Century Mine

RE: Response to Comments, Bennoc Area NPDES OIL00159 Application for American Energy Corporation in Belmont County, Ohio

Response to OEPA Comments from Bruce Goff and Eric Nygaard Dated 8/21/12, 8/15/12, 7/20/12, 7/13/12, and 7/11/12 Bennoc NPDES Permit Application OIL00159

Wheel treatment system – pictures provided by www.chemstream.com

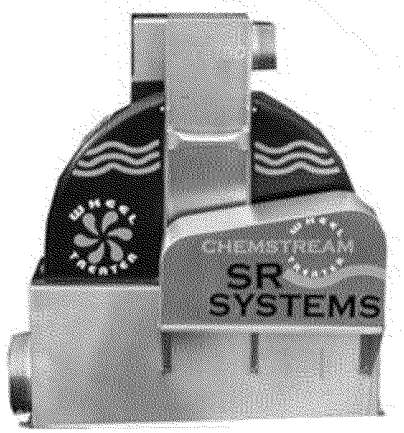
Comment: Do you happen to have any photos of the treatment ponds, the outlet structures, the chemical feed equipment and the discharge drainage ways (outlet ditches) you can share?

Response: We do not have any pictures of the proposed treatment ponds and their structures. However, we do have a picture (below) of the proposed wheel treatment system.
